DRAWINGS

REMARKS

FIG. 1A

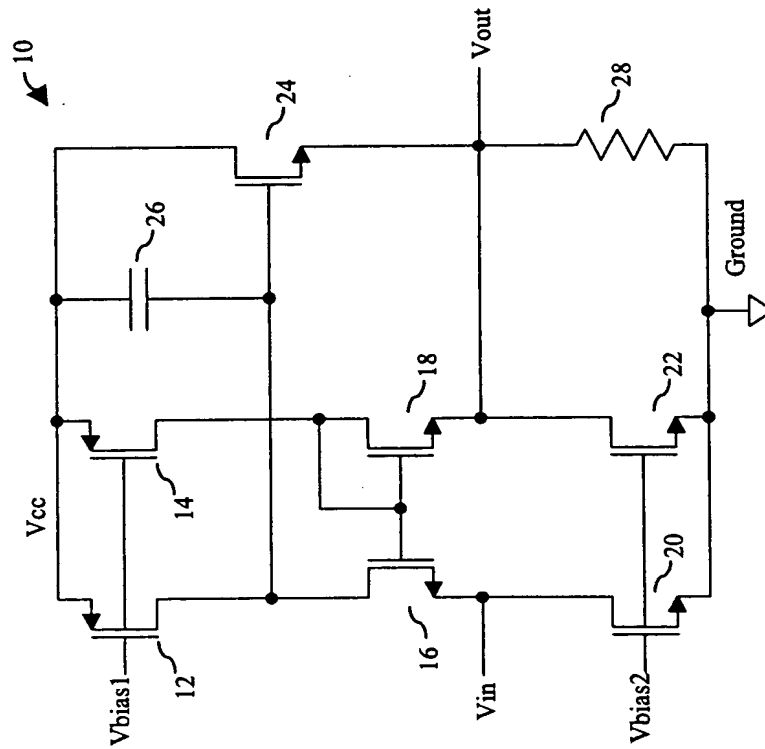
Please amend original FIG. 1 to now be referenced as "FIG. 1A" as shown in the attached Annotated Marked-Up Drawings, with changes indicated in pink highlight. Also please amend the drawings to include FIG. 1B. Attached are Replacement Sheets for the now-referenced FIG. 1A and FIG. 1B.

Applicants have amended original FIG. 1 to now be referenced as "FIG. 1A."

Applicants have included a new drawing FIG. 1B, which Applicants respectfully submit is fully supported by the Application as filed and does not add any new matter. In particular, FIG. 1B is substantially similar to original FIG. 1 in the Application, but replaces the transistors 12, 14, 20, and 22 with current sources as described at paragraphs [0013] and [0015] of the Application. Paragraph [0013] of the specification states: "During operation, transistors 12 and 14 may provide relatively constant current and, as such, can be considered or alternatively implemented as current sources." Likewise, Paragraph [0015] of the specification states, "During operation, transistors 20 and 22 may provide relatively constant current and, as such, can be considered or alternatively implemented as current sources."

[T]he disclosure “In precision buffer circuit 10, in some embodiments, only transistors 16, 18, and 24 are conducting signal currents. The remaining transistors- -i.e., transistors 12, 14, 18, 20 and 22 are conducting only bias currents, thus operating to provide relatively constant current” in page 5, paragraph [0001] is misleading. Figure 1 of the present application show that if transistors 12, 14, 20, 22 do not conduct signal currents, transistors 16, 18 and 24 will not conduct any current also because transistors 16 and 18 are isolated from supply source (Vcc and ground). Note that because transistors 12, 16, 20 and 14, 18, 22 are connected in cascode between supply voltage (Vcc) and ground, transistors 12, 16, 20 conduct a same current and transistors 14, 18, 22 conduct a same current.

claim 18 is fully supported and described in the specification, page 5, paragraph [0001]. This disclosure is misleading. Figure 1 of the present application show that if transistors 12, 14, 20, 22 do not conduct signal currents, transistor 16, 18 and 24 will not conduct any current also because transistors 16 and 18 are isolated from supply source (Vcc and ground).

The Examiner misunderstands what constitutes a “signal current.” In particular, not every current which flows through a transistor is a “signal current.” A signal current is one in which the magnitude can change in order to provide or indicate a signal. In the specification as filed, the currents flowing through transistors 16, 18, and 24 change during operation in response to changes in the input signal V_{in} . See pages 4-5 of the Application. For example, the specification states, “The slew rate $\Delta V/\Delta t$ may have a value equal to the quiescent current flowing in transistor 16 divided by the value of capacitor 26. Accordingly, less current flows through transistor 16. This causes the voltage at the gate of transistor 24 to increase, and thus, more current flows through transistor 24.” Thus, the currents flowing through transistors 16, 18, and 24 as described in the specification are signal currents.

In contrast, any current flowing through a transistor which is unchanging cannot be a “signal current”; otherwise, how could such current provide or indicate a signal. In the specification, the current flowing through transistors 12, 14, 20, and 22 are unchanging. The specification states: “During operation, transistors 12 and 14 may provide relatively constant current and, as such, can be considered or alternatively implemented as current sources.” Paragraph [0013]. Likewise, the specification states, “During operation, transistors 20 and 22 may provide relatively constant current and, as such, can be considered or alternatively

implemented as current sources.” Paragraph [0015]. As such, the currents flowing through transistors 12, 14, 20, and 22 as described in the specification are *not* signal currents. But these transistors 12, 14, 20, and 22 do conduct unchanging *bias* currents.

As explained above, the specification accurately describes that only transistors 16, 18, and 24 in Figure 1 of the Application provide signal currents. Transistors 12, 14, 20, and 22 do not provide any signal currents, but instead provide unchanging *bias* currents.

Furthermore, Applicants have included new drawing FIG. 1B which makes clear that in one embodiment only three transistors 16, 18, and 24 are conducting *signal* currents, as recited in claims 18-20. As discussed above, FIG. 1B is fully supported by the Application as filed and does not add any new matter.
